Kirby Morgan Dive Systems, Inc.®

Product Bulletin #11 of 2005 Hinge Bolt for Kirby Morgan Helmets, Part #530-027

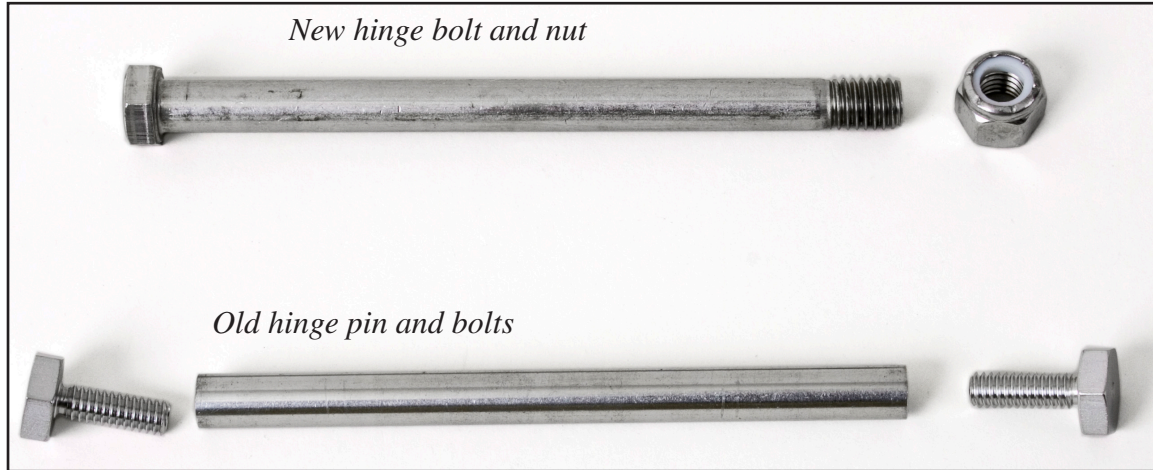
Kirby Morgan Dive Systems, Inc. has simplified the design the hinge pins on all of the KMDSI helmets with the introduction of the hinge bolt (530-027) and lock nut (530-028). This design replaces the previously used pin (550-275) and bolts (530-200).

The change simplifies the hinge design and helps eliminate line corrosion from developing inside the pin. The new design also eliminates the need for thread lock compound on the threads, reducing disassembly and cleaning time.

The new hinge bolt fits on Kirby Morgan models 27, 37, 17C, and 17K and will also be used on the 47, 57, and 67.
